## **Access Compliance Report Public Rights-of-Way** (Curb Ramps)

ADA ID: 1545ECD0F6C1 Ramp Type: PerpDiag Initial Pass/Fail: Fail **Overall Compliance: No Severity Score:** 12.5

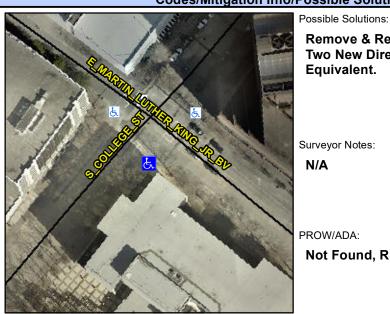
Not Found, R304.2.2

Compliance Description Data		Data	Comp	liance Description	Data
N/A	Ramp Length (in)	44.0	No	Ramp Slope (%)	8.5
Yes	Ramp Width (in)	48.0	Yes	Ramp XSlope (%)	1.1
N/A	Flare Type LT	N/A	N/A	Flare Type RT	N/A
N/A	Flare Slope LT (%)	N/A	N/A	Flare Slope RT (%)	N/A
N/A	Flare Traversable LT?	No	N/A	Flare Traversable RT?	No
N/A	Landing Length (in)	N/A	N/A	DWS Provided?	N/A
N/A	Landing Width (in)	N/A	N/A	DWS Contrast?	N/A
N/A	Landing Slope (%)	N/A	N/A	DWS Length (in)	N/A
N/A	Landing X Slope (%)	N/A	N/A	DWS Full Width?	N/A
N/A	Landing Curb? (Y/N)	N/A	N/A	DWS Offset (in)	N/A
N/A	Shared Landing?	N/A			
N/A	Gutter Ponding?	N/A	N/A	Gutter Slope (%)	N/A
N/A	Gutter Lip Ht (in)	N/A	N/A	Gutter X Slope (%)	N/A
N/A	Painted X Walk1?	Yes	N/A	Painted X Walk2?	Yes
	X Walk 1 Direction	To NE		X Walk 2 Direction	To NW
N/A	X Walk 1 Width (in)	113.0	N/A	X Walk 2 Width (in)	112.0
	X Walk 1 Slope (%)	6.4		X Walk 2 Slope (%)	3.8
	X Walk 1 X Slope (%)	3.4		X Walk 2 X Slope (%)	5.2

Remove & Replace Curb Ramp With Two New Directional Ramps or Equivalent.
